TDECQ Considerations

Associated with Comment No. 351 on 802.3dj D2.1

Review of Cl 121.8.5.3

Figure 121-5—Illustration of the TDECQ measurement

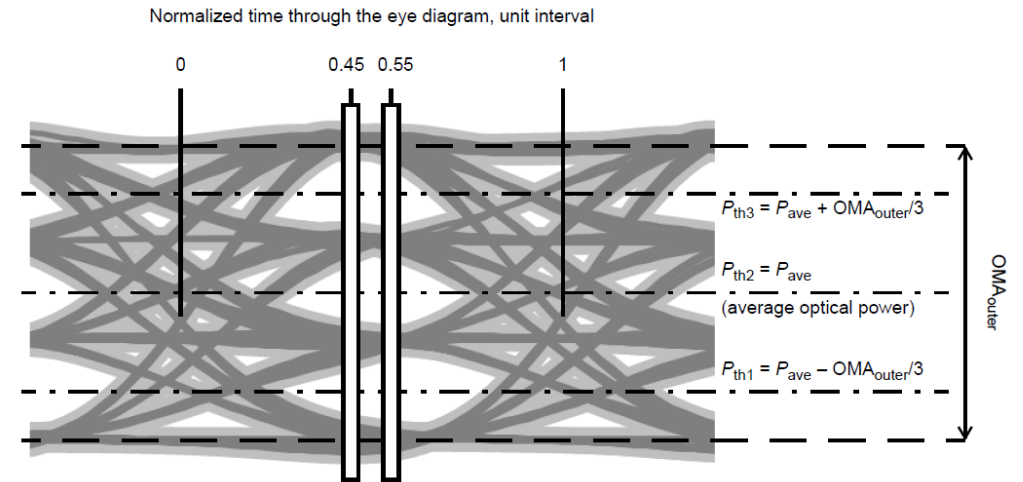
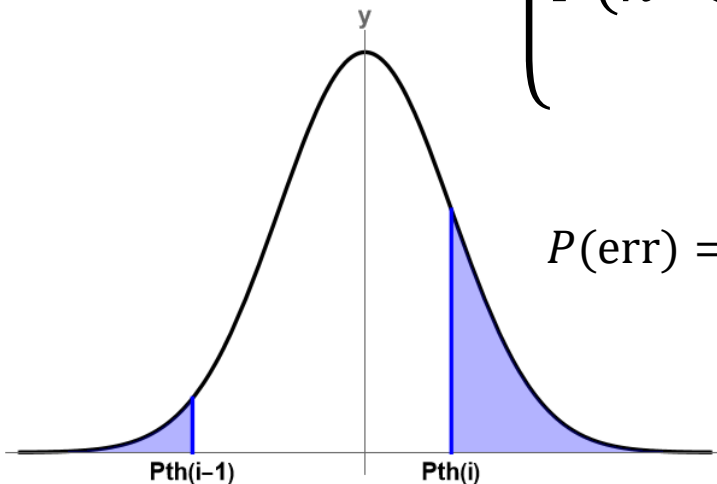
- Clause 121.8.5.3 does not compute symbol error rate this way
- Instead, clause 121.8.5.3 attempts to condition the probability of error on the value of the noise and then sum over the different noise values.
- It does this for each of three thresholds, then sums those three probabilities for the final probability of symbol error
- The two methods are not mathematically equivalent, because the tail of the gaussian distribution is being ignored at the largest magnitude y_k values
- Ahmad El-Chayeb has indicated in a (semi) private communication that the two methods give the same result in practice at the SNRs considered (so far)
 - Depends on the SNR and how close y is to the nearest threshold
 - Depends also on the maximum magnitude y_k value considered
- This should be fixed for future readability and to ensure repeatability with different implementations

where n is Gaussian noise of the proper variance. The problem with this approach is when $y_i = y_{\max} \equiv \max\{y_i\}$

In that case, $\text{Prob}(T_1 \leq y \leq y_{\max})$ should not be weighted by $\text{Prob}(n = T_1 - y_{\max})$

Instead it should be weighted by $\text{Prob}(n \leq T_1 - y_{\max})$; otherwise we are ignoring the tail of the Gaussian distribution.

The second problem with the computation of symbol error probability in TDECQ is that it computes the probability of making an error by crossing $T1$, $T2$, and $T3$ independently, then adds those probabilities together to get a total probability. But this is double or triple counting in some cases, since a given y value has a certain probability of crossing one (or sometimes two, if an internal region) thresholds, and it does not make another symbol error if it crosses the next threshold.

All of these problems could be avoided by using the more conventional error probability conditioned on the value of y and then using the Q function to determine the probability of crossing a threshold out of the original zone.

$$\sum_{\{y_i | T_1 < y_i < y_{\max}\}} \text{Prob}(n = T_1 - y_i) CF_1(y_i) + \text{Prob}(n \leq T_1 - y_{\max}) CF_1(y_{\max}) \quad (2)$$

$$\begin{aligned} & \sum_{\{y_i | y_{\min} < y_i < y_{\max}\}} \text{Prob}(n = T_1 - y_i) CF_1(y_i) \\ & + \text{Prob}(n \geq T_1 - y_{\min}) CF_1(y_{\min}) \\ & + \text{Prob}(n \leq T_1 - y_{\max}) CF_1(y_{\max}) \quad (4) \end{aligned}$$
